**FEDERAL RECALL 04KW8
PROCEDURE**

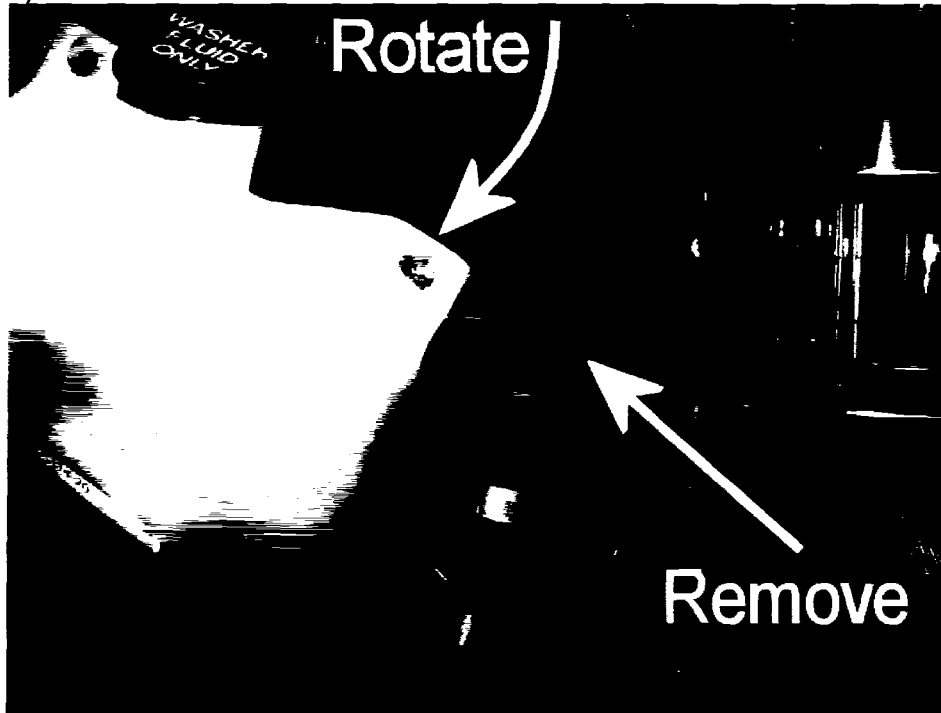
- 1) Disconnect negative battery cables.
- 2) Remove 3 of the 4 screws that hold the washer bottle.
- 3) Rotate washer bottle to access the main power feed cable to the Power Distribution Box (PDBox).
- 4) Remove cable from PDBox.

- 5) Cut ties holding the cable, following the cable to the battery box.
- 6) Disconnect cable from the 135 amp circuit breaker and also the jumper to the starter relay.
- 7) Destroy original cable by cutting both ends off.
- 8) Install new P92-1993-XXXX cable (see ECAT for XXXX length):
 - a. Connect wire number P21AL/P84SR to 135 amp circuit breaker
 - b. Connect wire number P84SR to starter relay.
 - c. Connect wire number P21AL to PDBox. Torque nut to 8 -13 Lb*ft (11 - 17.6 Nm).
- 9) Tie strap cable as factory installed and ensure at least 1/2" clearance with the steering driveline.
- 10) Reinstall washer bottle and connect negative battery cables.
